# BCUA CSO Group

## CSO LTCP

### Selection and Implementation of Alternatives Report

Final August 30, 2024

Figure 2-2: Proposed 89 Acre Sewer Separation Area and Phases

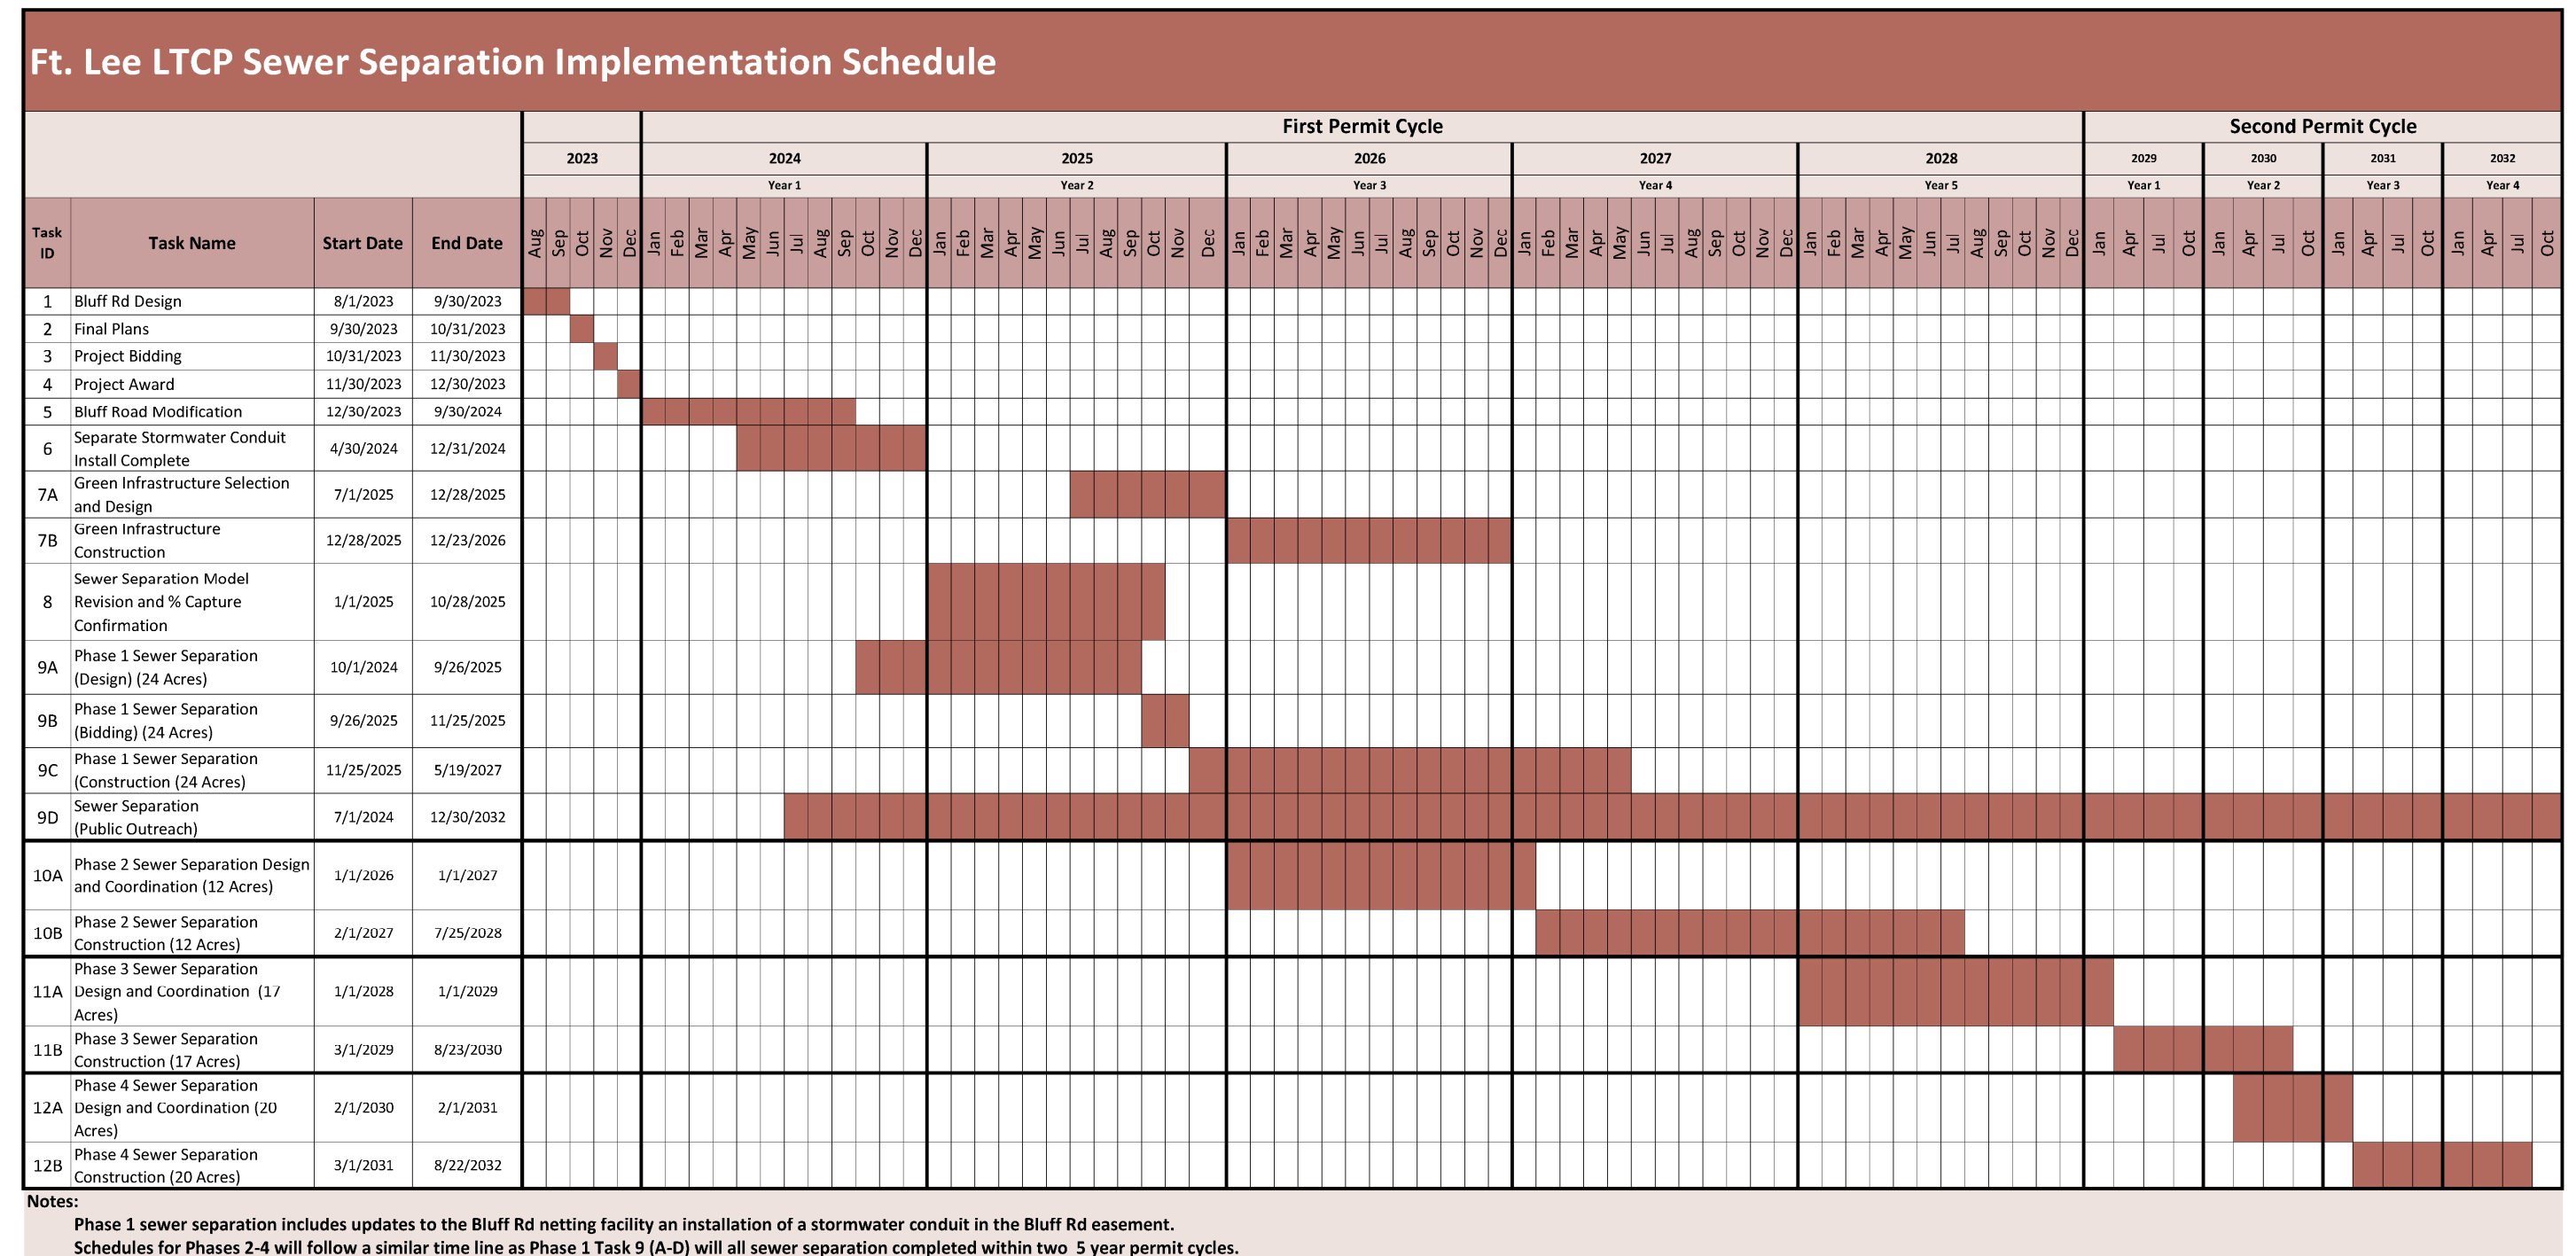
Comment 6: Section 2.2.4 , Operational Plan, Schedule, and Post Construction Compliance Monitoring includes Figure 2-2 namely a map of Fort Lee as follows:

Provide additional information to supplement Figure 2-2:

- a) In order to show the relative effect of sewer separation, revise Figure 2-2 to designate which portions of Fort Lee are currently served by a combined sewer system versus a separate sewer system. In addition, label the location of the existing CSO outfalls.
- b) Expand and revise Figure 2-2 to indicate the locations of the five phases of sewer separation.
- c) Figure 2-2 states "Tentative location of the separation location" and is labeled "Example of the Delineation of the 60 Acre sewer Separation Area." Given that this is an LTCP, it must include the selected alternatives and not indicate tentative locations. The Department is concerned that there is not a firm plan or commitment to sewer separation given these labeling designations. Please explain.
